Product Change Notification / KSRA-06MRSR308

CCB 4610 Final Notice: Qualification of a new lead frame with Full PPF die attach paddle (DAP) surface prep material for DSC11xx, DSC12xx and DSC81xx device families available in 6L VDFN (7x5x0.9mm) package at NSEB assembly site.

PCN#: KSRA-06MRSR308

CCB 4610
Pre and Post Change Summary
PCN#:KSRA-06MRSR308

Lead frame comparison

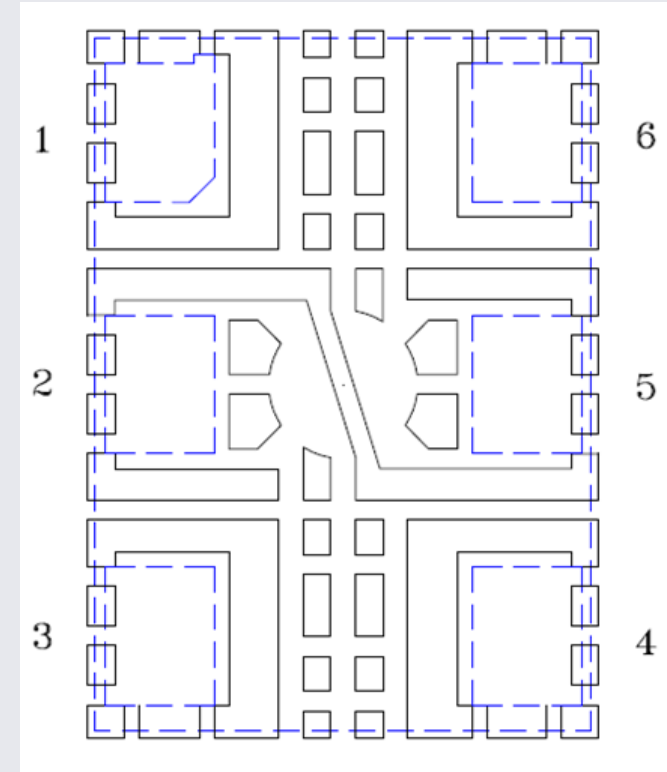
Lead frame DAP surface Prep

Selective PPF

Lead frame DAP surface Prep

Full PPF
